Update Figure 33-14

IEEE802.3bt

Sep 2015

Yair Darshan

Figure 33-14: Current IEEE802.3 D1.2

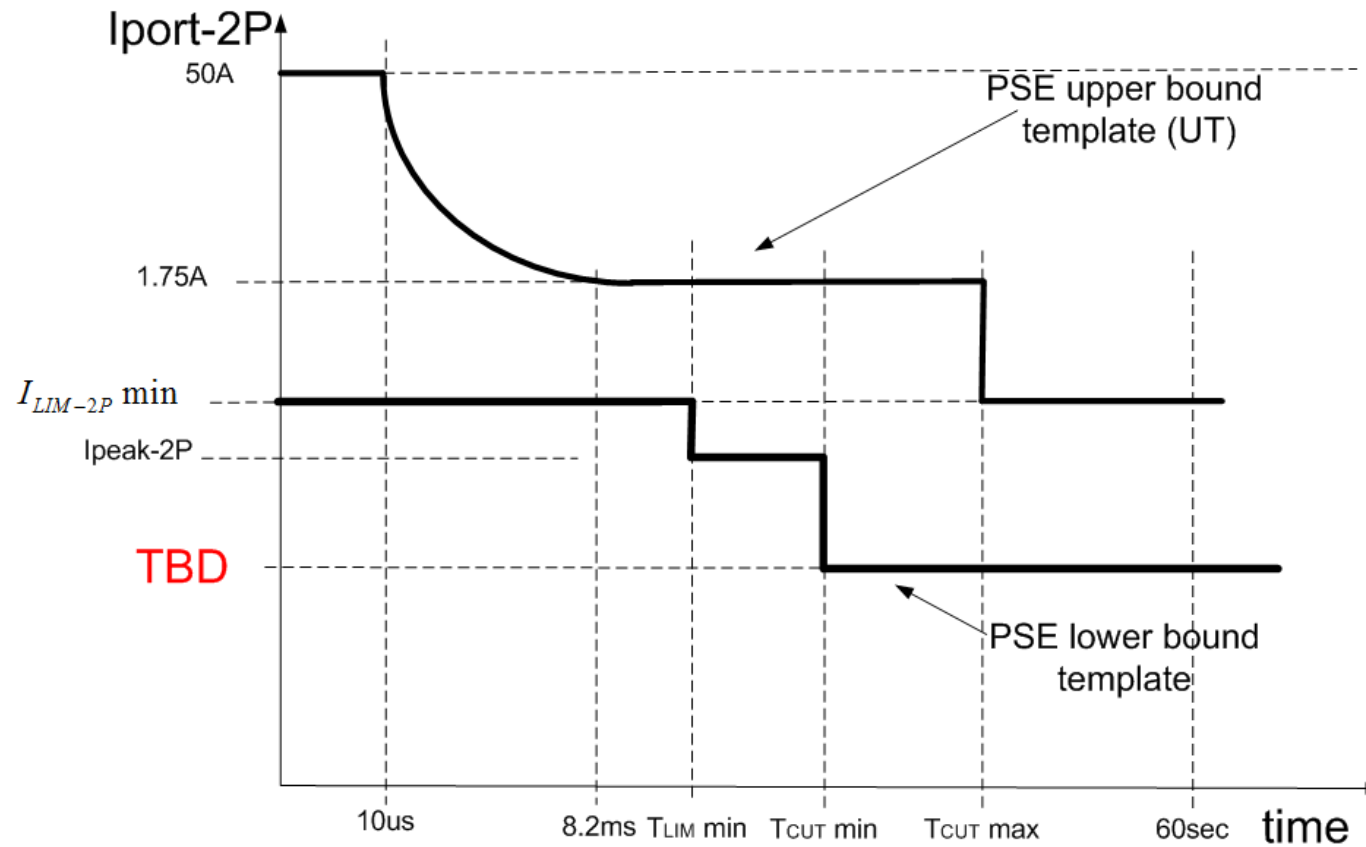
- The TBD we need to address

The TBD we need to address is the long term lower bound current that PSE has to supply

The TBD is the lowerbound that PSE has to supply

If the TBD is I_{con-2P_unb} what it means?

- It means that for that pairset this is the minimum current that I have to support since I don't know what PD will be connected and what are the unbalance conditions.
- Does it means that I need to supply $2 \times I_{con-2P_unb}$?

No! it means that your protections are set at I_{con-2P_unb} or above and you will supply up to total I_{con} current

We can add a normative text that says:

I_{con-2P} can vary between $I_{con} - I_1$ to I_{con-2P_unb} were I_1 it the other pair current.

I_{con-2P} is equal to I_{con-2P_unb} at the worst case.

The total current that PSE has to support is I_{con} and not $2 \times I_{con-2P_unb}$.

The actual current on the pair set may be lower according to the following equation:

$$I_{con-2P} = \min(I_{con} - I_1, I_{con-2P_unb}).$$

Optional combined Figure 33-14 for Type 1,2,3

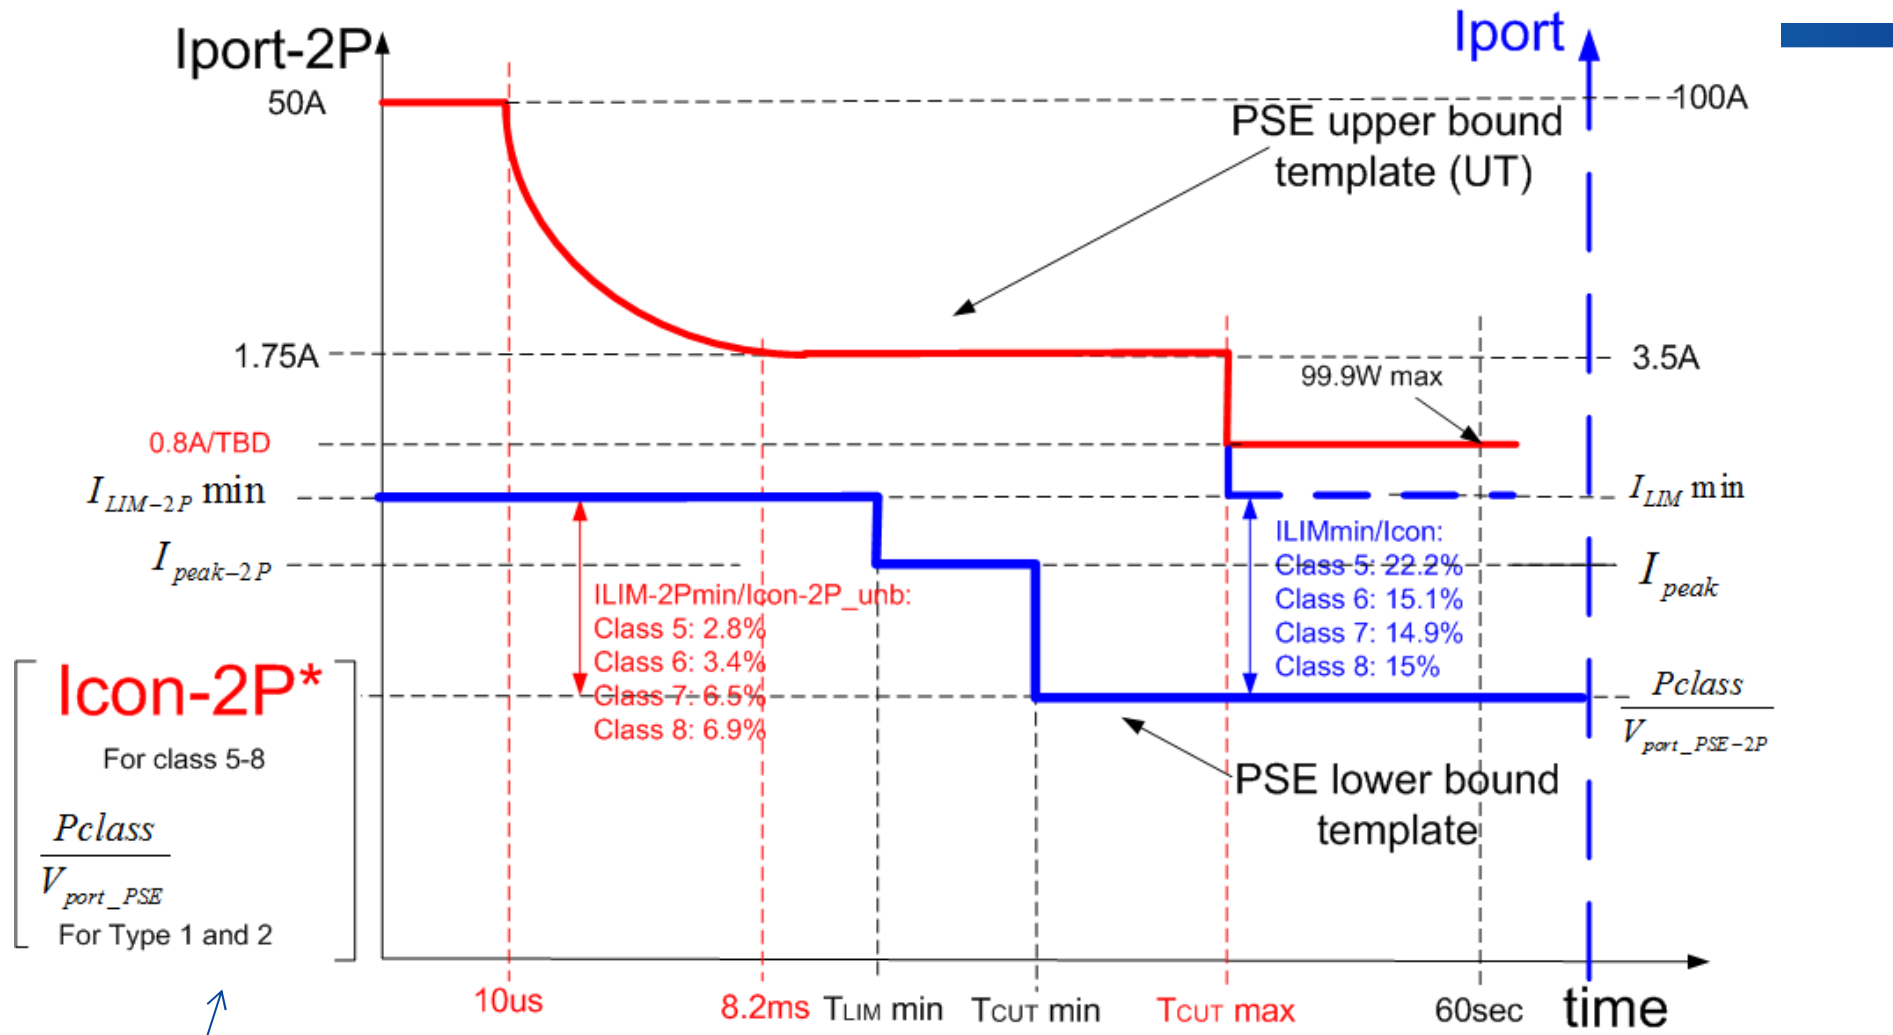
The TBD

- To verify that Type 4 can use the same drawing as Type 3 or different drawings are required.
